Work Order ID 126771

Item Name: Clip

ENGINEERING CHANGE NOTICE NL 04510

ENGINEERING CHANGE NOTICE NO. 02866

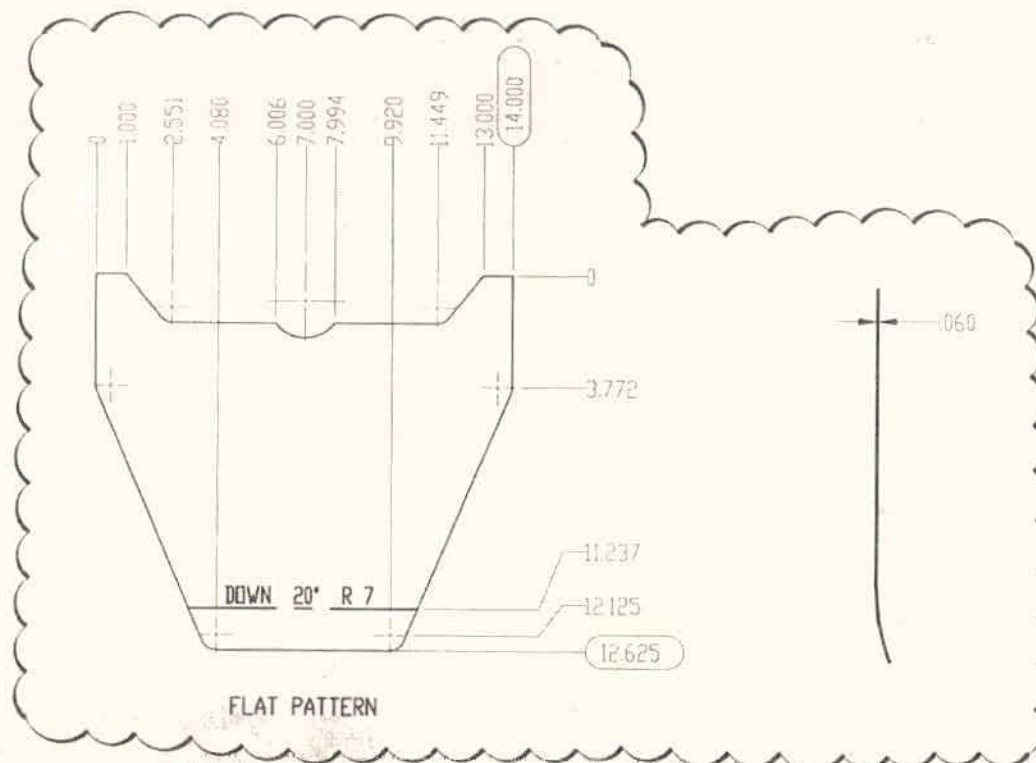
REASON: MODIFIED DOUBLER.

SHEET 1, ZONE C2 IS:

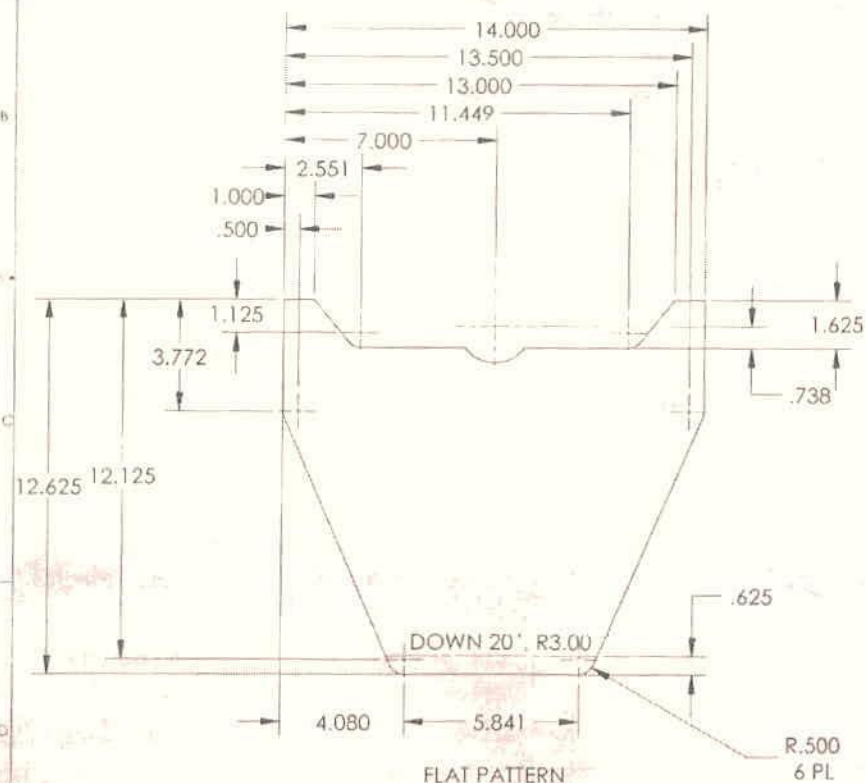
REASON: CHANGED PRETREATMENT CALLOUT

SHEET 1, ZONE A1 IS:

2. FINISH: HARD ANODIZE IAW MIL A-8625 TYPE II,
CLASS 2, COLOR BLACK
PRETREAT PR-148 ADHESION PROMOTER
PRIME IAW MIL-P-33277J TYPE I CLASS N

647.4113 SHOWN
647.4112 OPPOSITE

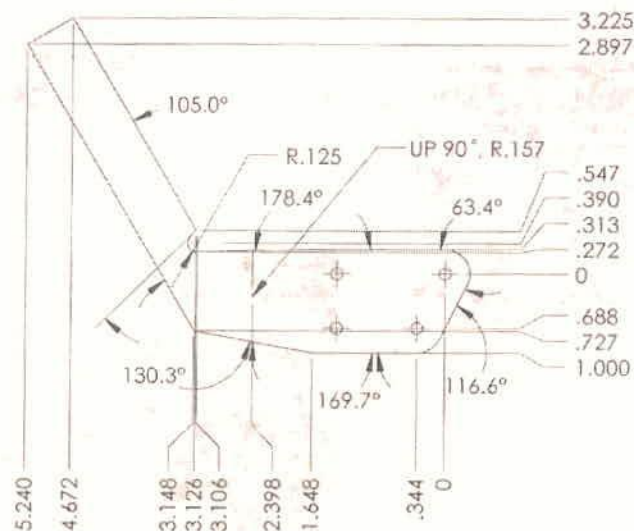
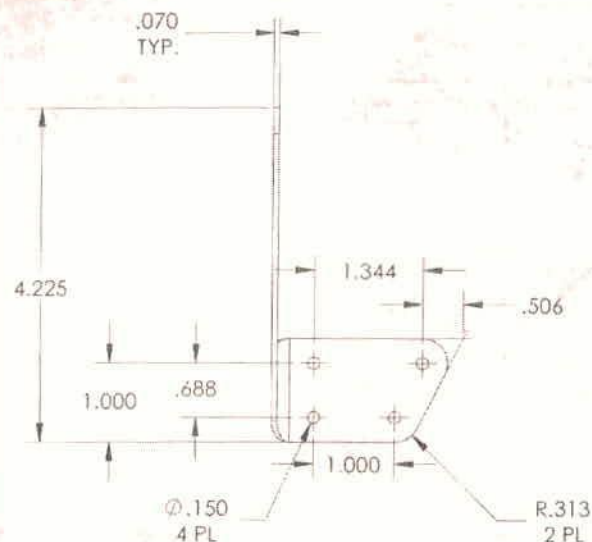
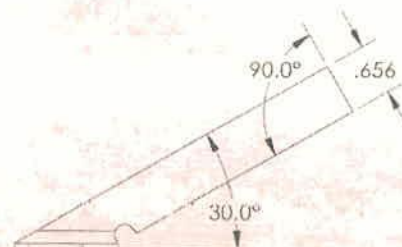
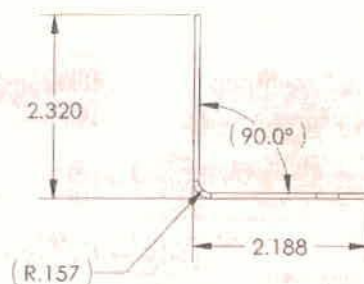
Hi Pablo,
There seems to an error in the flat pattern on the dwg, Marc Bellavance had a quick look and came up with the file attached.

What is happening is the flat pattern is too long in the mid section(see snip below).

Hi Linda,
New Flat pattern has been programed and is on the network.
See below for Pablo's e-mail to attach to the w/o.
Attached is a temporary dim sheet to reflect the new dimensions.
JL

From: Jean-Luc Menard
Sent: August-13-14 11:07 AM
To: Pablo Bravo
Cc: Marc Bellavance; Sylvie Boucher (sboucher@dartaero.com)
Subject: 647.4113/647.4112 FLAT PATTERN ERROR

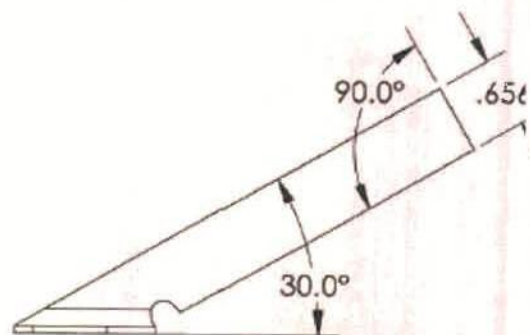
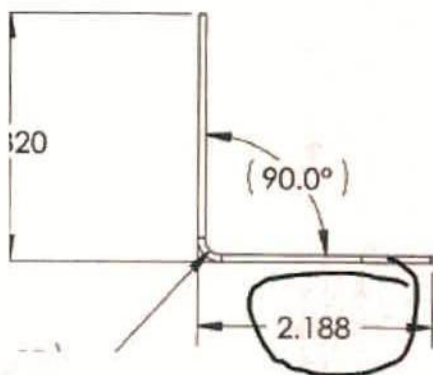
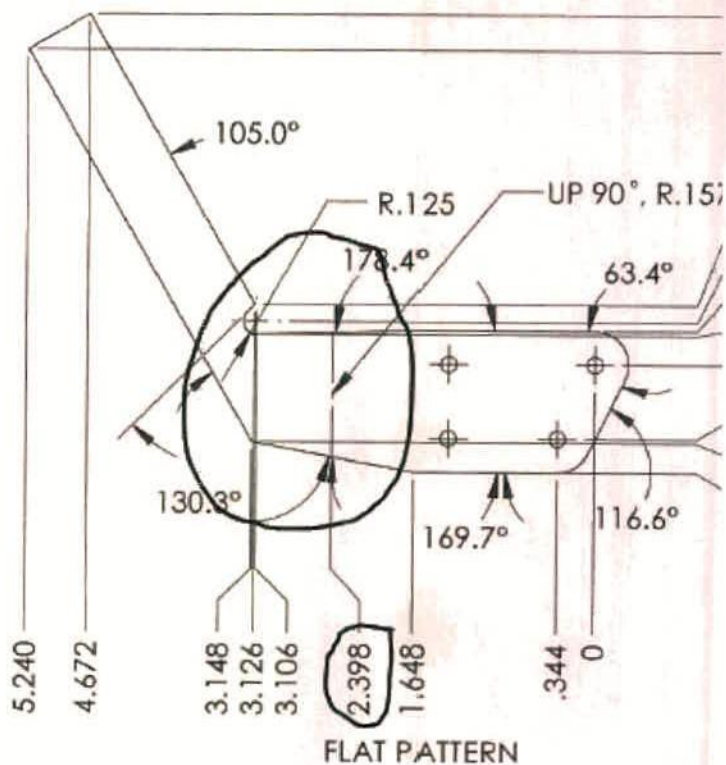
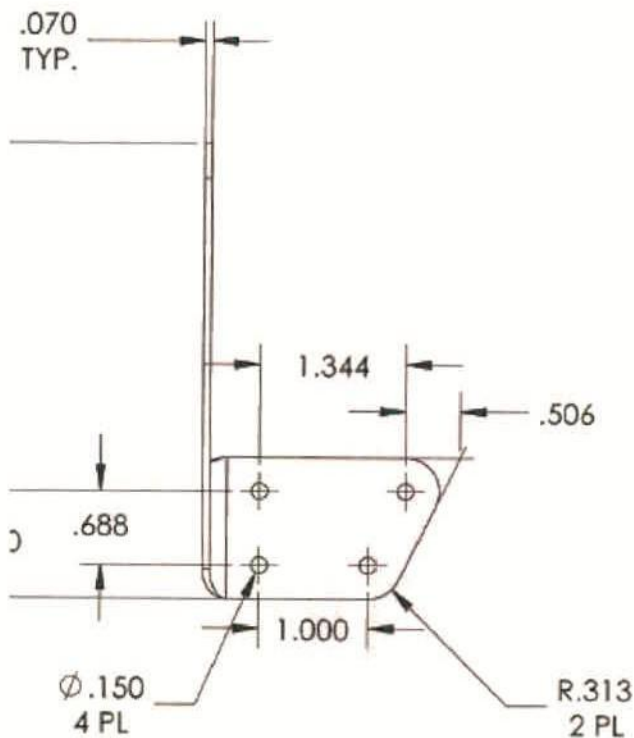
Let me know if you need me to issue an ecr for this one, and if we can continue with Marc's updated flat pattern.

If you agree with Marc's pattern, I will attach the email to the w/o so we can continue production.

The flat pattern is acceptable. We'll need to get the drawing updated.

Tyler, can you please update the drawing as soon as possible?
